## IDAP REPORT – SECTION 4.55(1A) MODIFICATION

<b>Property:</b>	5 Torrington Road STRATHFIELD LOT: 19 DP: 582 DA2021.77.2
<b>Proposal:</b>	Section 4.55(1A) Modification Application for alterations and additions to height, floor levels, basement layout and ground and first level dimensions.
<b>Applicant:</b>	P Kokuleraaj
<b>Owner:</b>	S. Paramsothy
<b>Date of lodgement:</b>	17 January 2022
<b>Notification period:</b>	N/A
<b>Submissions received:</b>	NIL
<b>Assessment officer:</b>	G I Choice
<b>Estimated cost of works:</b>	\$1,381,429.00
<b>Zoning:</b>	R2-Low Density Residential - SLEP 2012
<b>Heritage:</b>	<b>No</b>
<b>Flood affected:</b>	Yes
<b>RECOMMENDATION OF OFFICER:</b>	Approval

**Figure 3:** Proposed basement plan

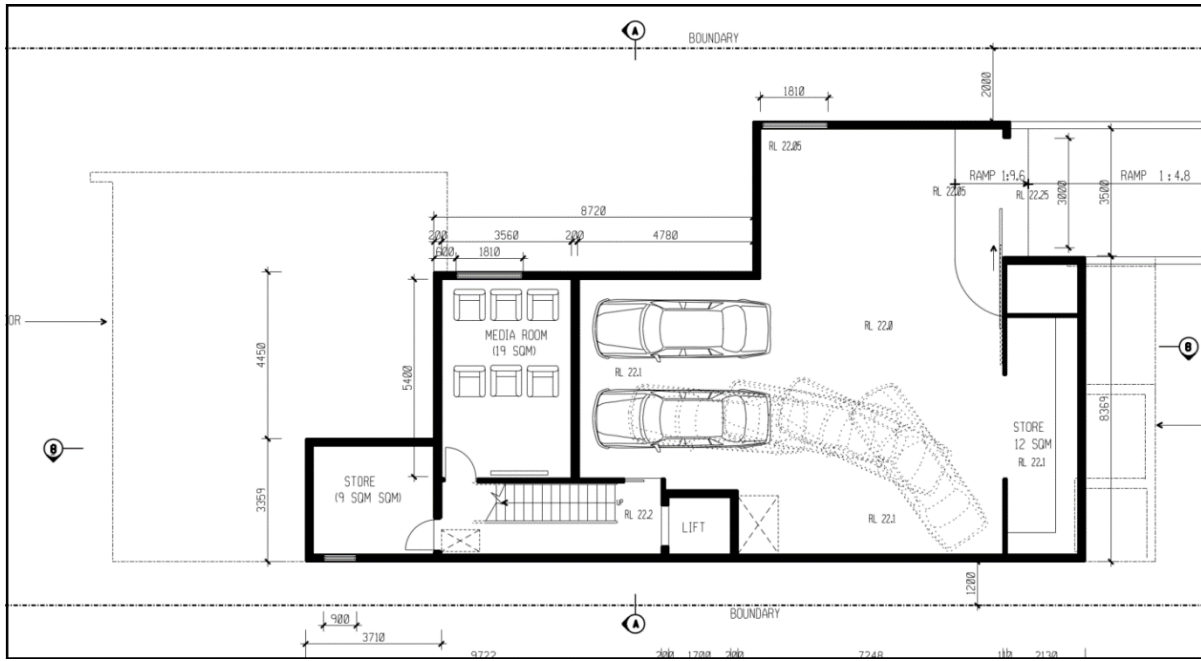
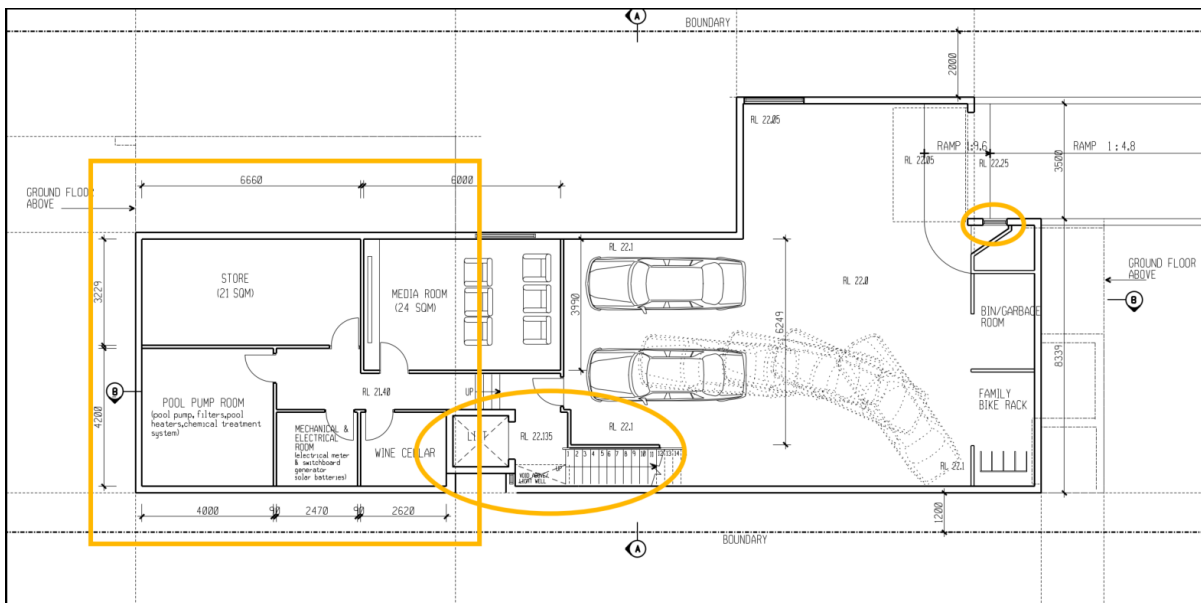
- Reconfiguration of stairs, lift and store room (basement to first floor)
- Addition of pool pump room, mechanical/electrical services room, wine cellar and bike rack
- Increase of media room and storage room floor area

**Figure 5:** Proposed ground floor plan

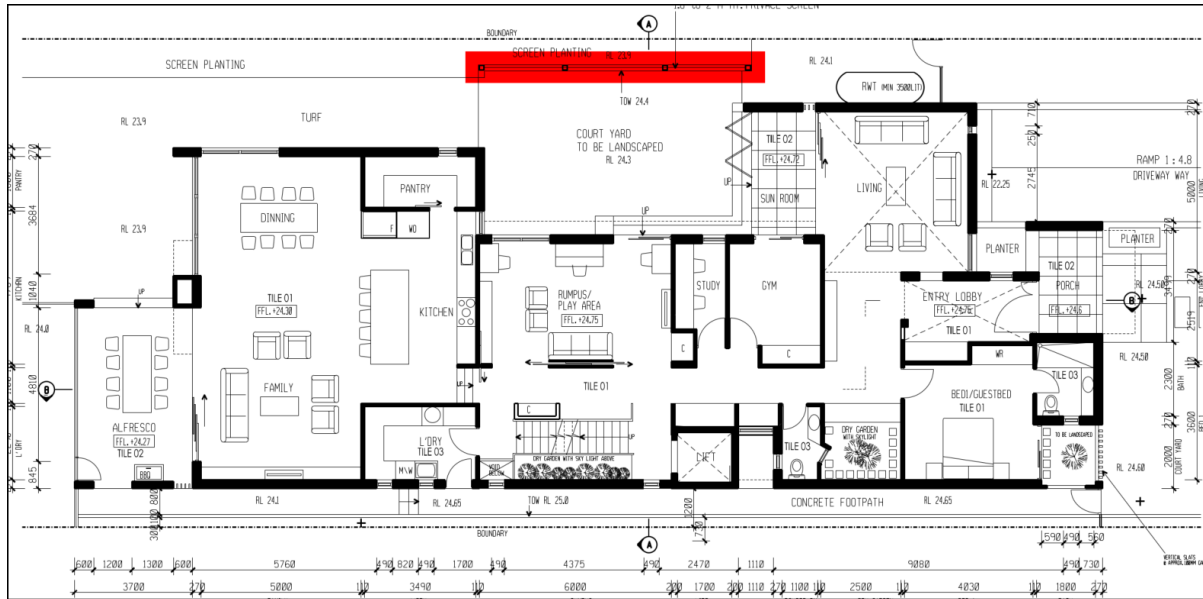
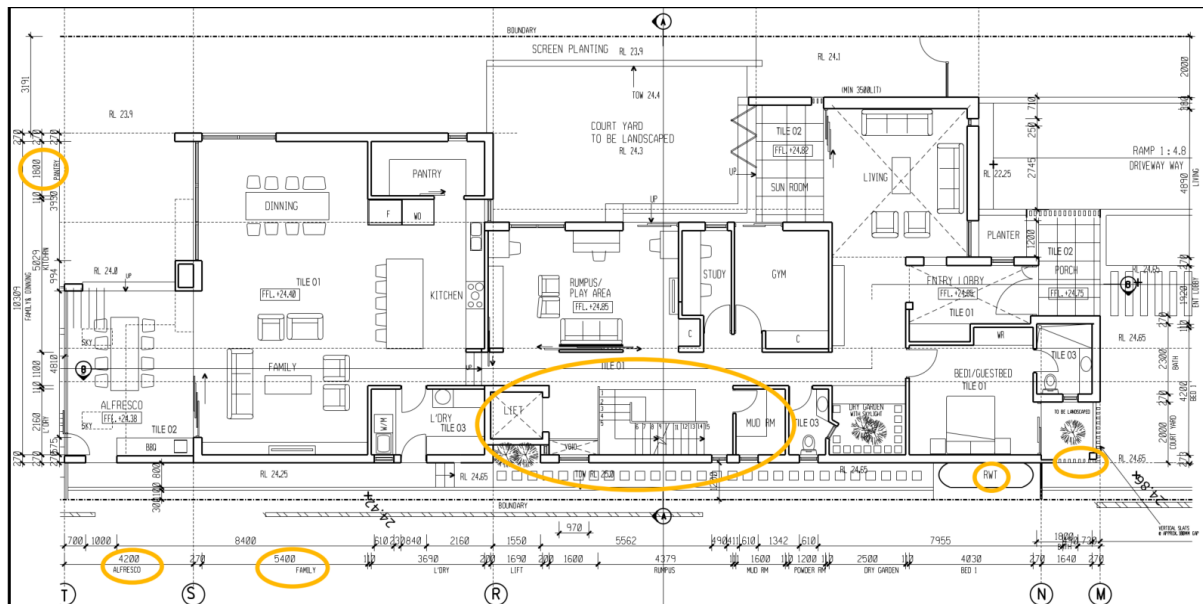
- Deletion of dry garden on west wall near stairs
- Addition of mudroom
- Relocation of the RWT to the west elevation
- Slight increase of open plan family/dining/kitchen area, pantry and sunroom dimensions.
- Raise FFL by 100mm (and overall building height)

**Figure 4:** Approved ground floor plan (red highlighted screen deleted)

Amendments made in red on approved plans	All changes made in red on the approved plans shall be updated and shown on the Construction Certificate plans.
Delete Courtyard Privacy Screen	The courtyard privacy screen on the eastern boundary shall be deleted. A privacy screen may be added to the plans. The screen must be aligned with the living area/sun room wall. The screen shall be a maximum length of 4.5m and a maximum height of 1.8m.

Figure 7: Proposed first floor plan

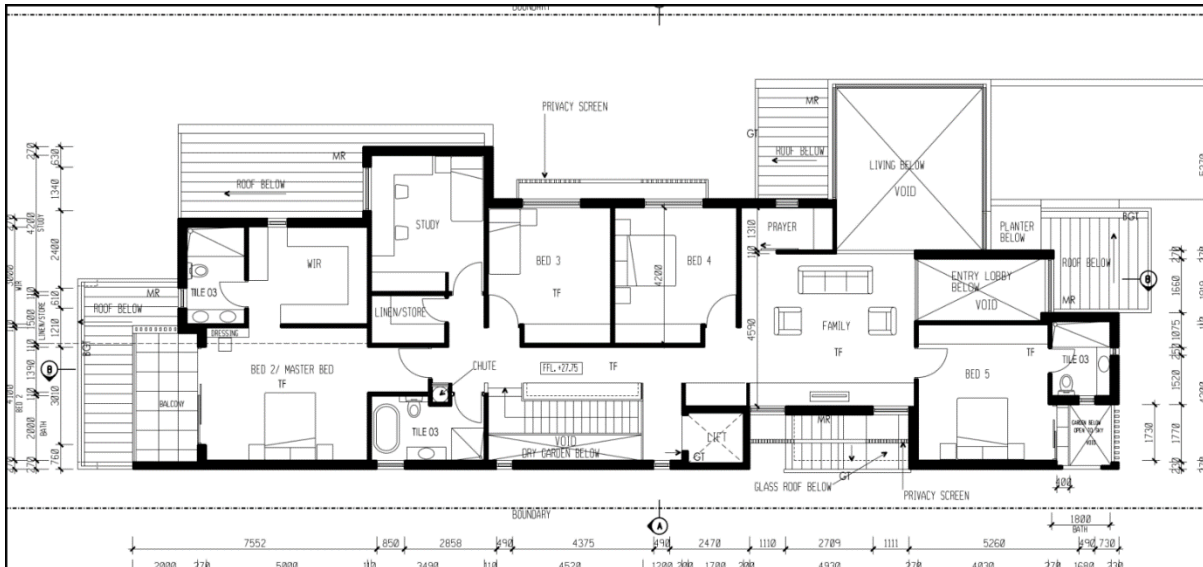
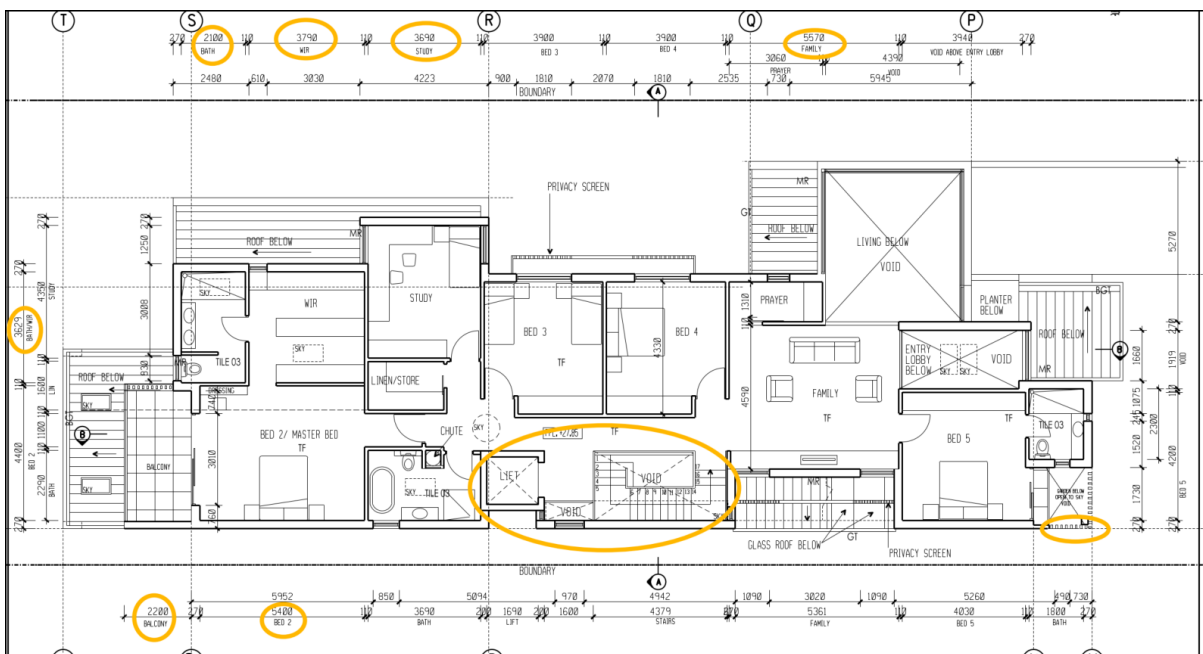
- Slight increase of Bedroom 2 en suite and WIR; and study floor area open plan
- Addition of privacy screening to Bed 5 balcony
